The Legacy Way Project (formerly known as Northern Link Road Tunnel)

Coordinator-General's report on project changes

December 2010

Figure 2.1 General alignment—changed project

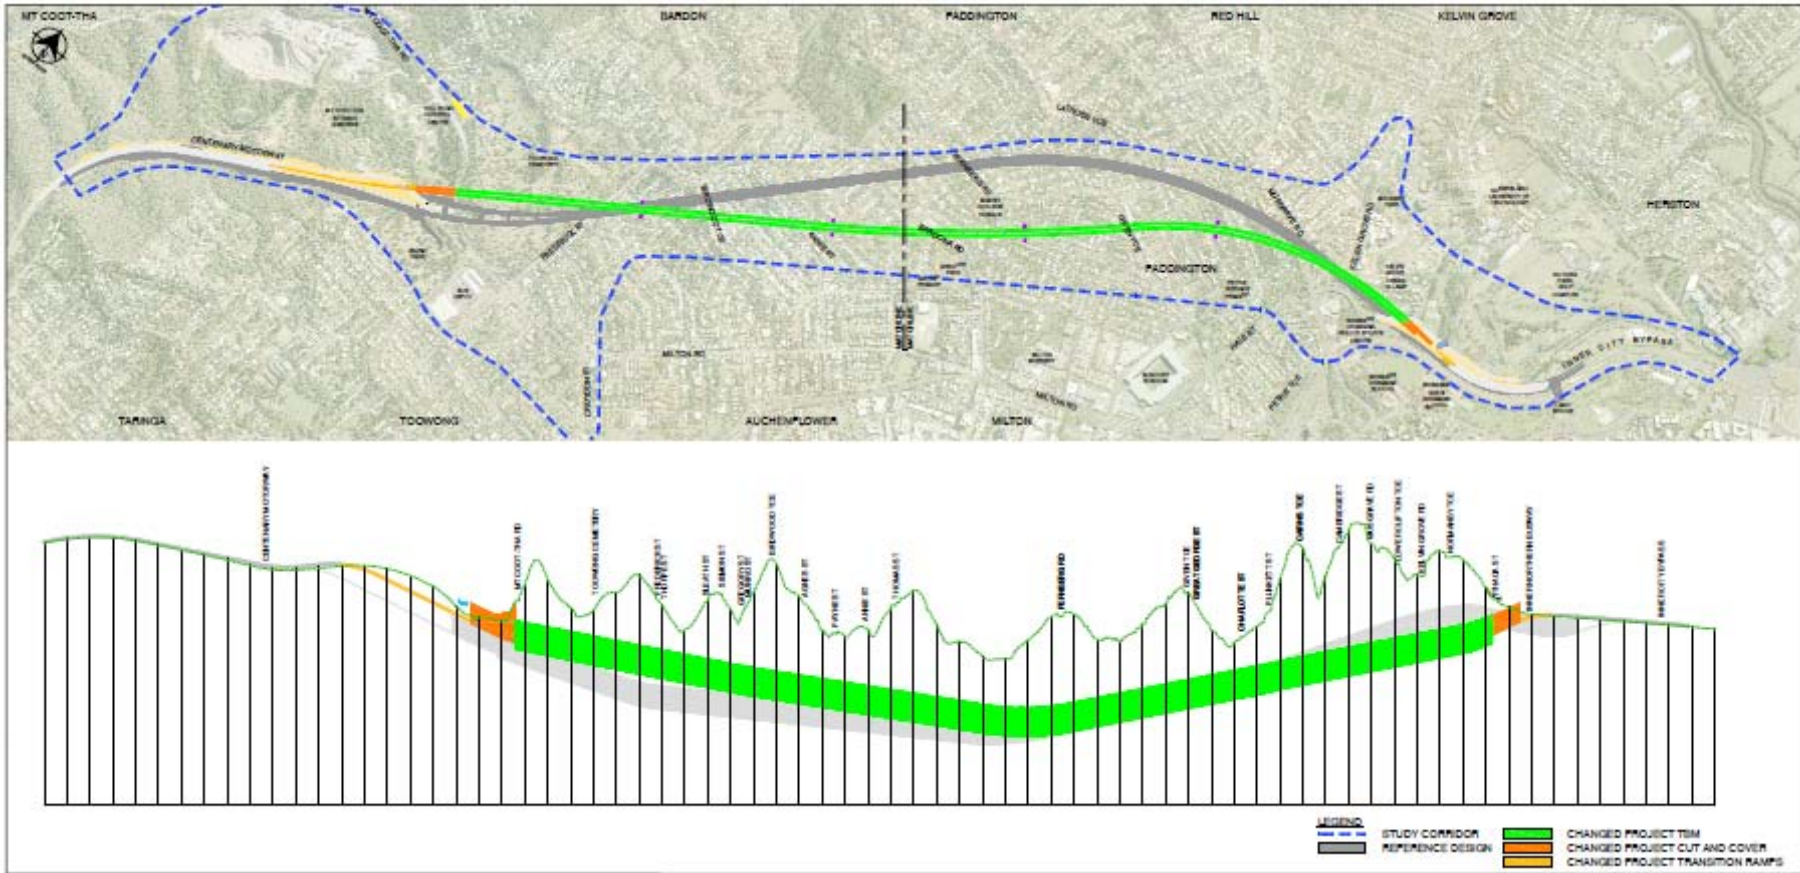
The main alignment between the connections would differ from the RD by commencing at the western side of Mt Coot-tha Road, approximately 100 metres north of the RD alignment (see top of figure 2.1). The main alignment would pass under the Toowong Cemetery in a straighter route than the RD, then swing up to 300 metres south of the RD to connect with the ICB on the southern side of Normanby Terrace, at a location close to that proposed in the RD.

The vertical alignment of the tunnels is proposed to be shallower for most of the route, except for the section from Cairns Terrace, Kelvin Grove Road and Normanby Terrace, in the vicinity of the ICB connection (see base of figure 2.1).

The APC confirms the vertical alignment of the tunnels is proposed to be shallower for most of the route, except for the section in the vicinity of the ICB connection from Cairns Terrace, Kelvin Grove Road and Normanby Terrace (see base of figure 2.1).

Figure 2.2 Changed project—eastern connection overview

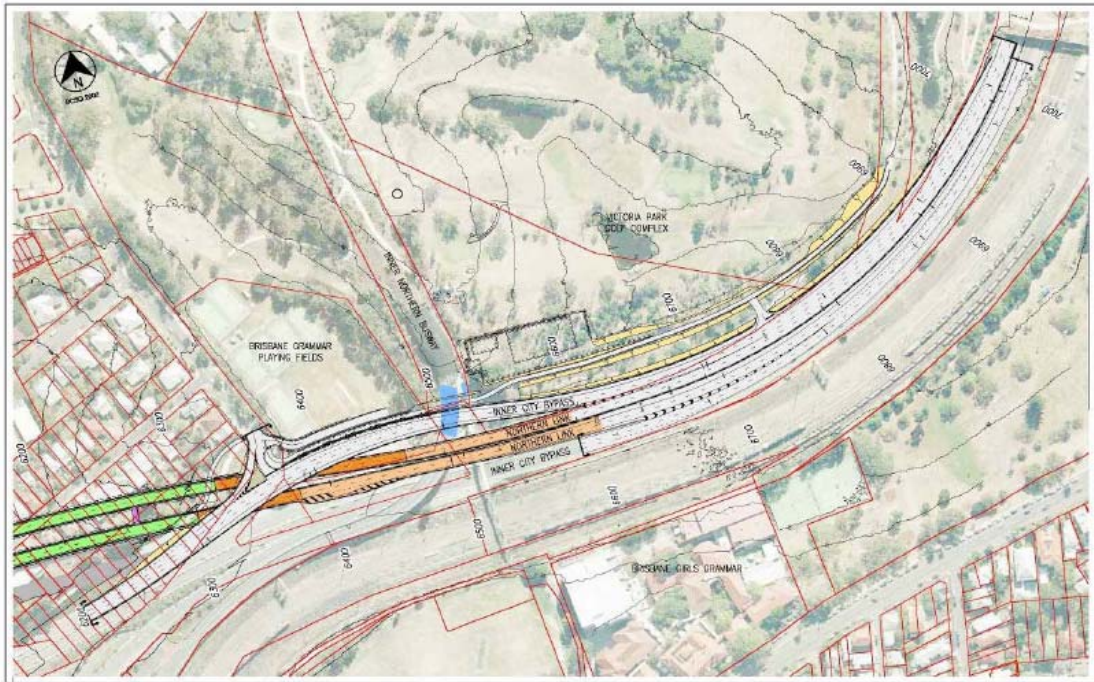
The transition ramps between the LW portals and the ICB would be together in the centre of the ICB and extend from in line with the Brisbane Girls Grammar School (BGGs) to the tunnel portals between Victoria Park Road and the Inner Northern Busway (INB) overpass (see figure 2.2).

The realignment of the eastbound ICB lanes would require a widened median and would therefore involve increasing the land required over the Brisbane Grammar School (BGS) playing fields. A new span for the INB would also need to be constructed. Construction of a temporary bridge for buses is proposed to ensure use of this section of the INB is not unduly interrupted.

Figure 4.3 Proposed temporary workforce construction parking—Anzac Park

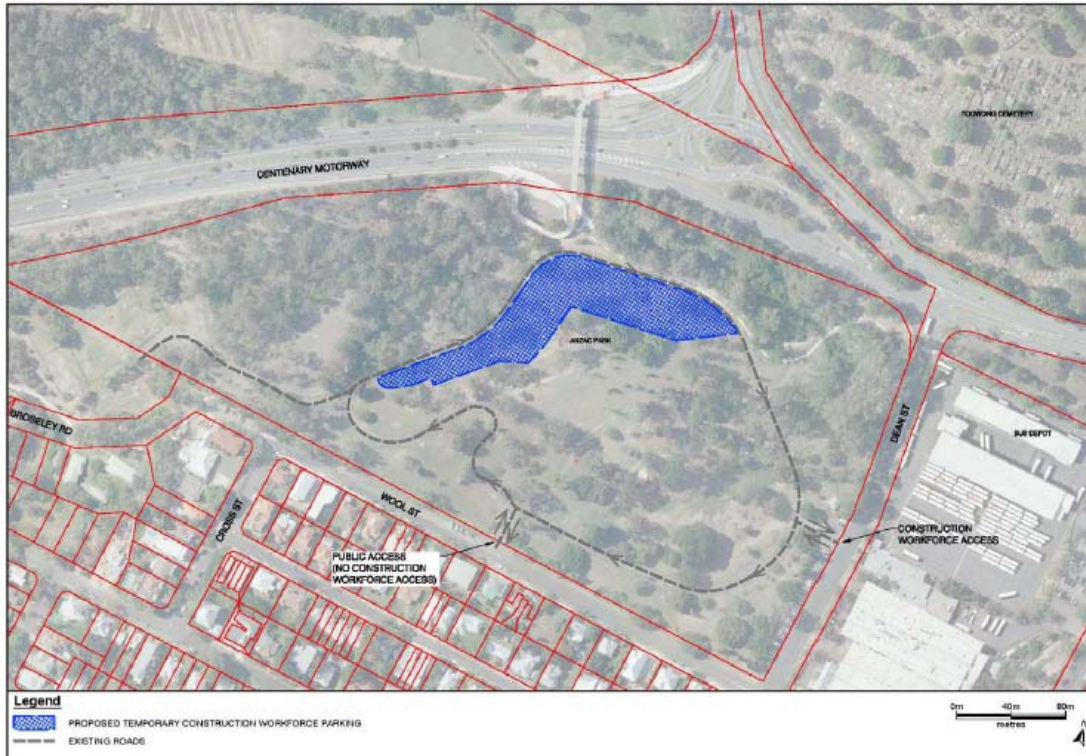
In response to this requirement, the APC proposed to establish a temporary workforce car park in a section of Anzac Park, Toowong, for up to 300 vehicles (see figure 4.3).

BCC confirmed the car park would be used by workers who would walk approximately 550 metres across the pedestrian/cyclist overpass to access the western worksite.

- Decrease the size of the car park from a maximum of 300 car spaces to a maximum of 200 spaces.
- Re-seal the section of the ring road that would provide access to the workforce car park (from Dean Street) to allow dual access.

While there is merit to the proposal and the refinements proposed by BCC provide greater detail about how the proposal's impacts will be managed, further consideration of alternate locations is required in order to understand if locating parking elsewhere would reduce disturbance to the community while providing a workable solution for the project. The part of the project changes application that relates to the request to locate temporary car parking in a section of Anzac Park as provided in this change process is therefore refused.

Therefore, this report refuses the Anzac Park proposal as provided within this current project change process.
